7 Magnolia Parkway, Chevy Chase
HPC Case # 3513-100 C
Chevy Chase Village Historic District

From: Silver, Joshua
Sent: Tuesday, October 14, 2008 8:42 AM
To: 'Heather Cass'
Subject: RE: 7 Magnolia Parkway, Chevy Chase

SUBJECT: Historic Area Work Permit #476406, rear addition

RE: ADDITION TO 7 MAGNOLIA PARKWAY, CHEVY CHASE
WEST STOOP REVISION

FRONT ELEVATION - WEST STOOP

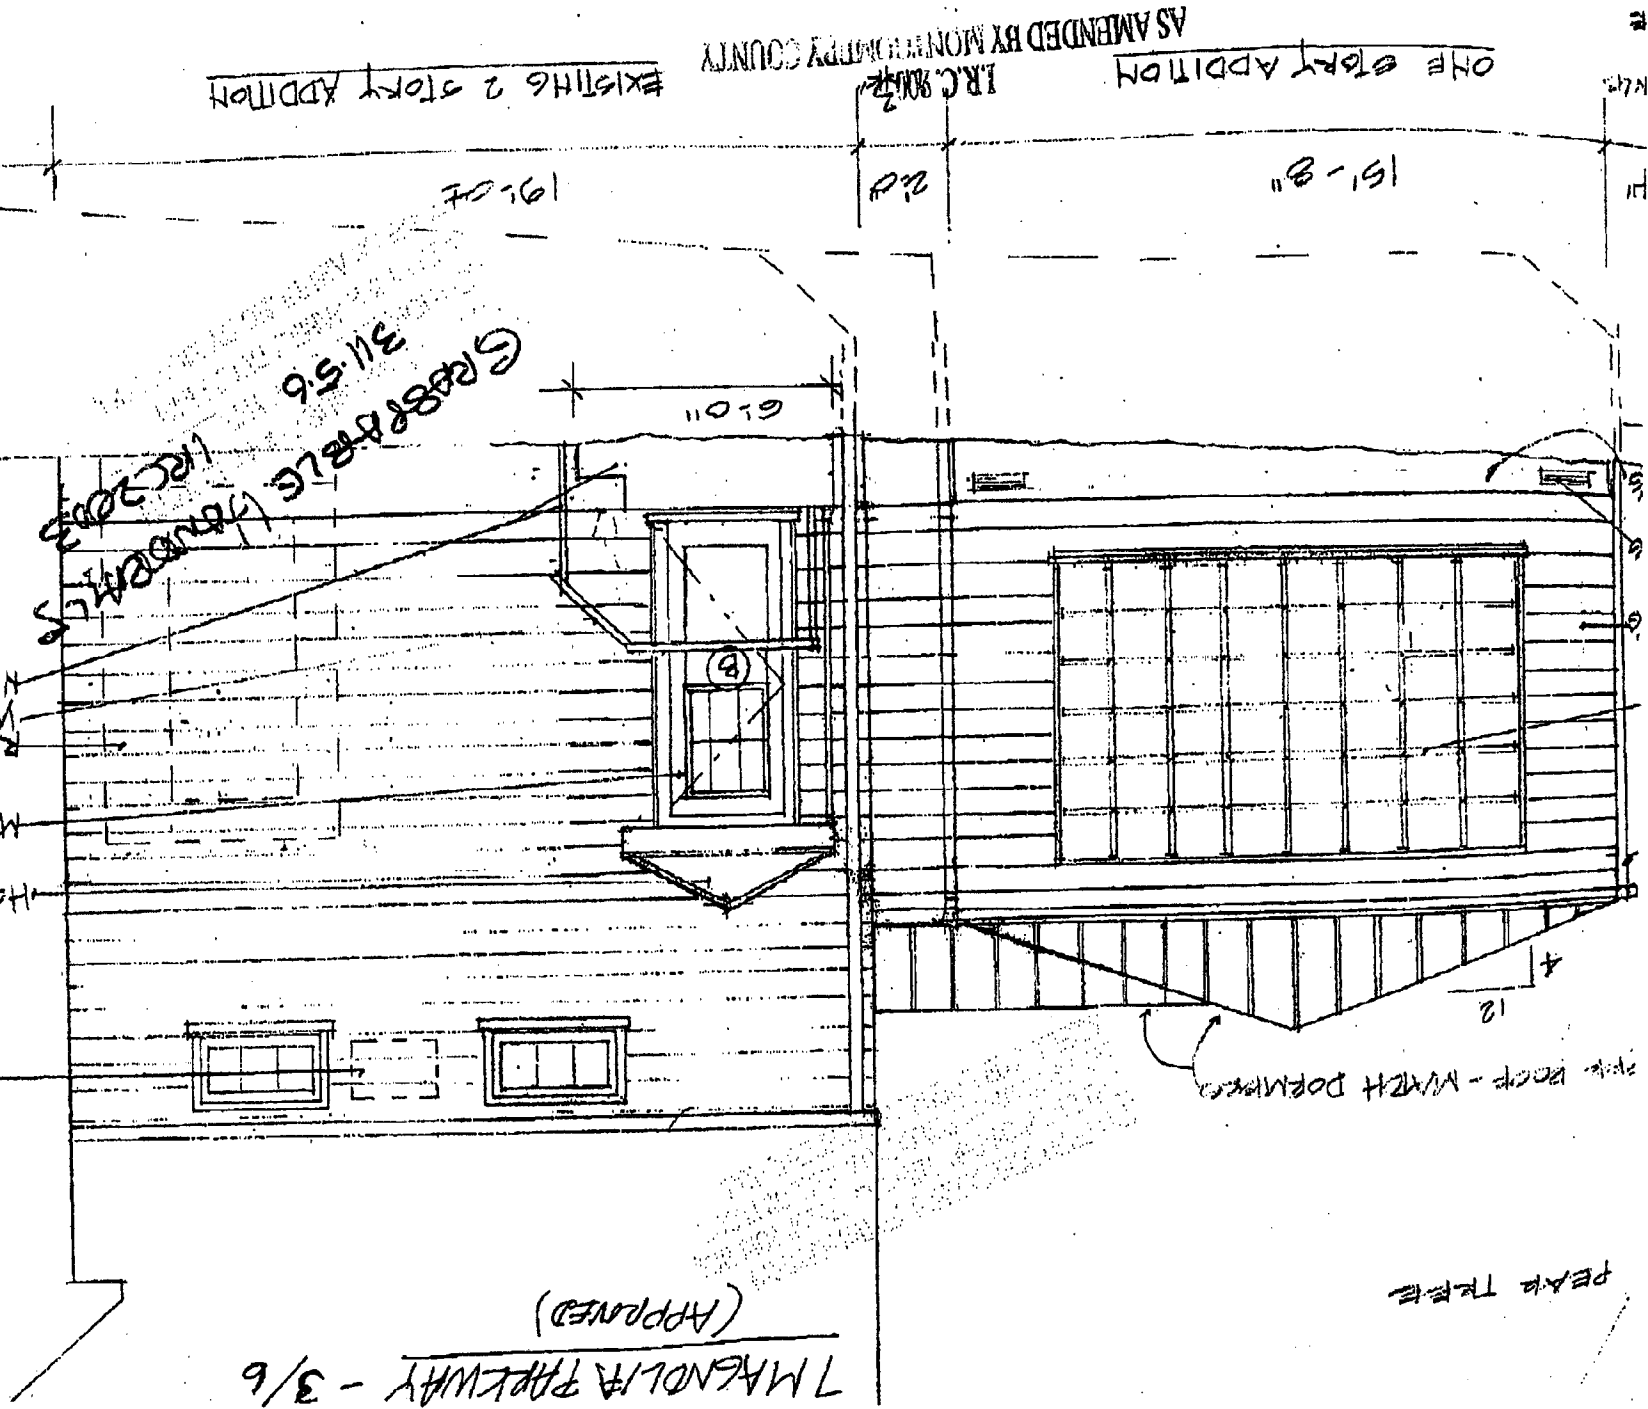
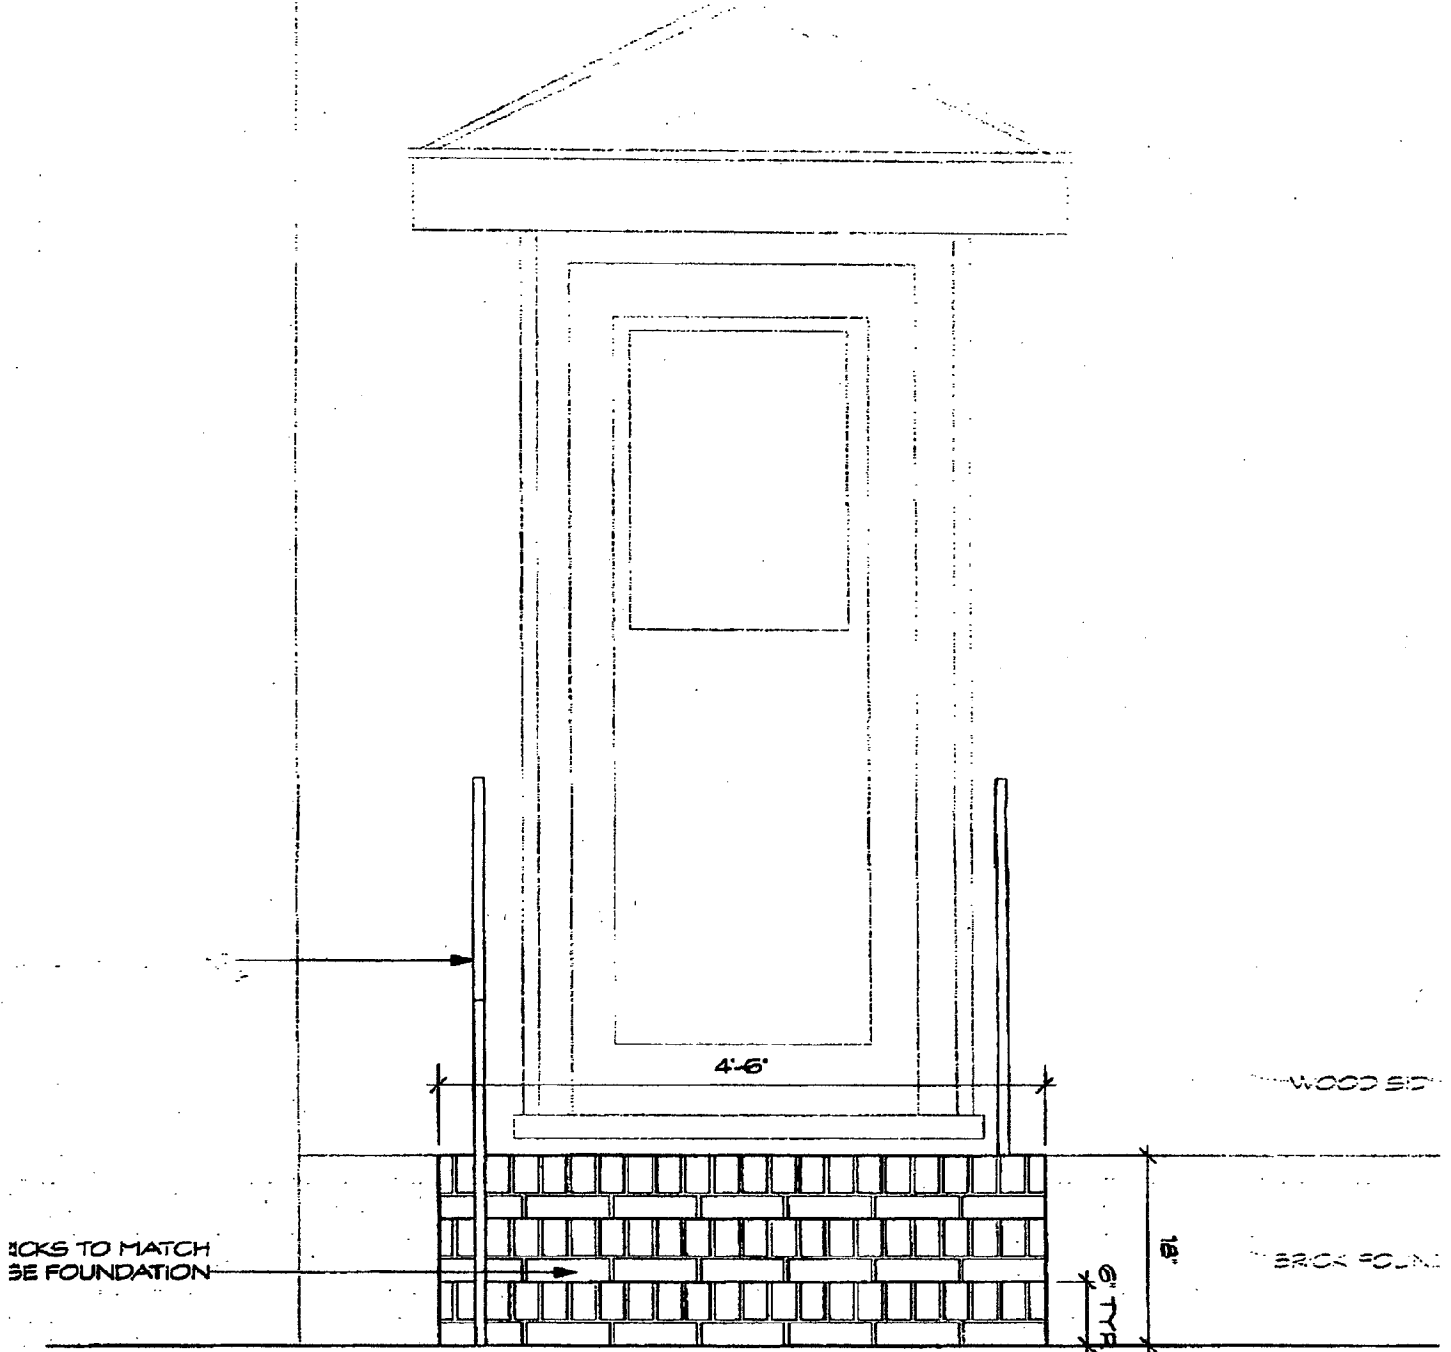
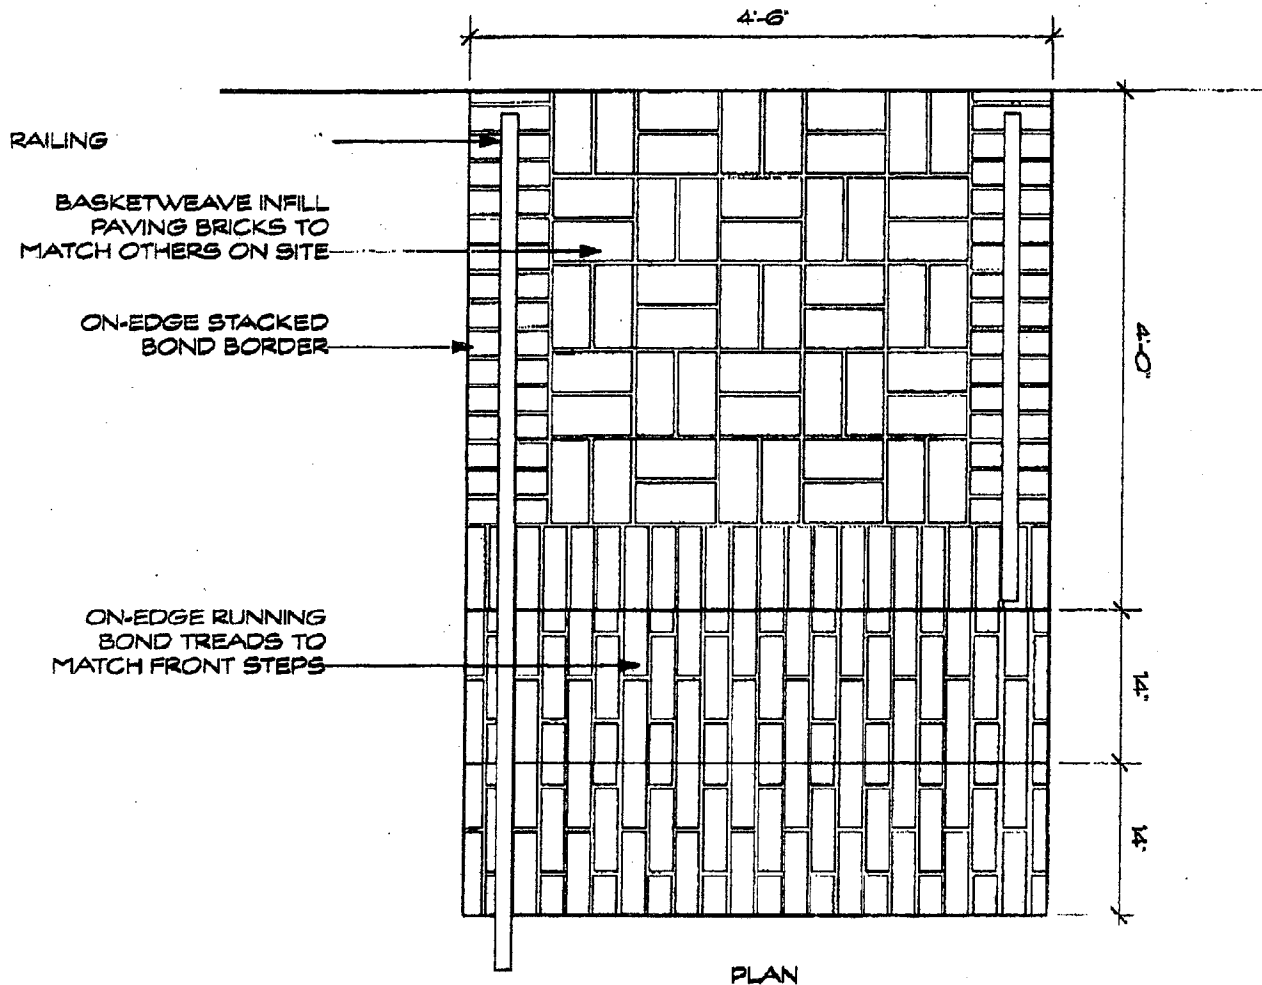
Attached are copies of the original plan and elevation showing the approved design for the west stoop, as well as copies of the revised proposal. Only the steps change: from concrete to brick to match the foundation, and to go straight out (as the old steps did) instead of turning. The door and door hood are unchanged.

REMOVE DOOR
WROUGHT IRON
NEW CONC ETC
MOVE/REMOVE
HOOD TO MATCH

Thanks for faxing in your revised proposal for the stairs. Your request to change the material of the steps on the west elevation from concrete to brick and change their orientation from loading on the side to the front is approved.
